PROJECT: Oak Cliff Est. 3rd

REFERENCE: Drainage Concept for proposed replat

Final plat
SUBDIVISION REPORT

Name: Oak Cliff Estates 3rd Addition

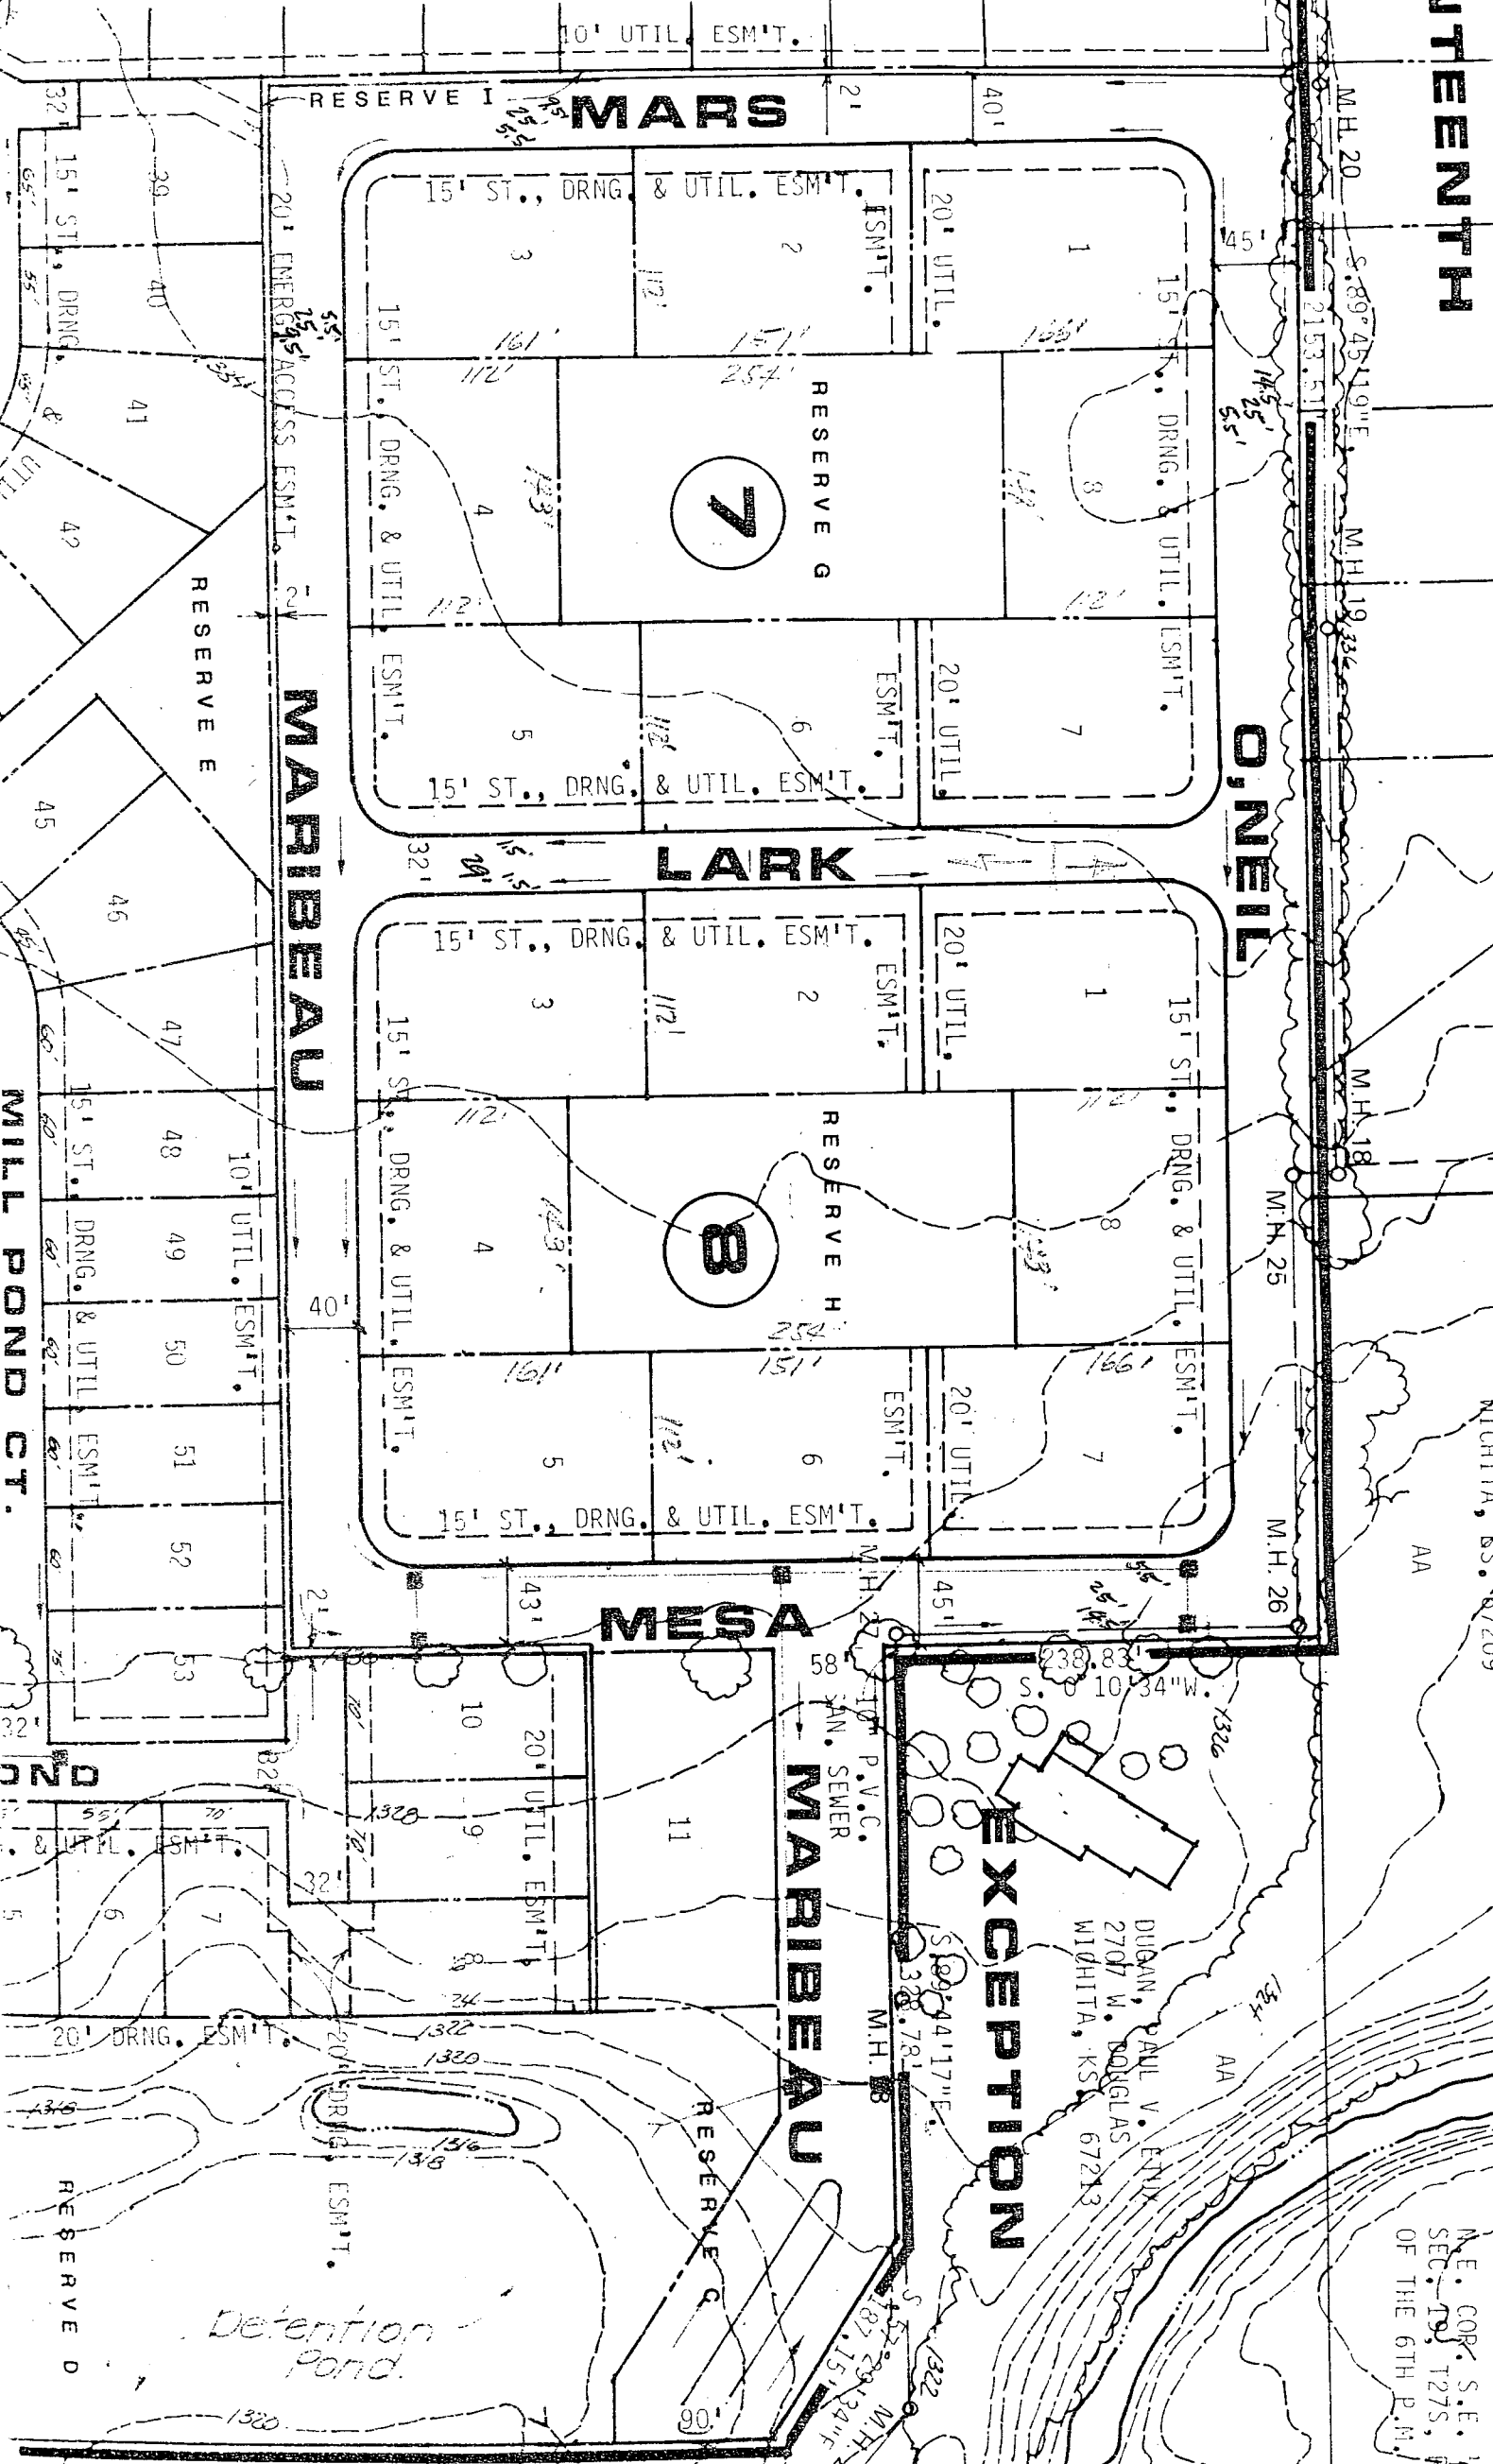
Need final Drainage Calculation including detention Pond design to determine Min. Pad requirement in Block 9.
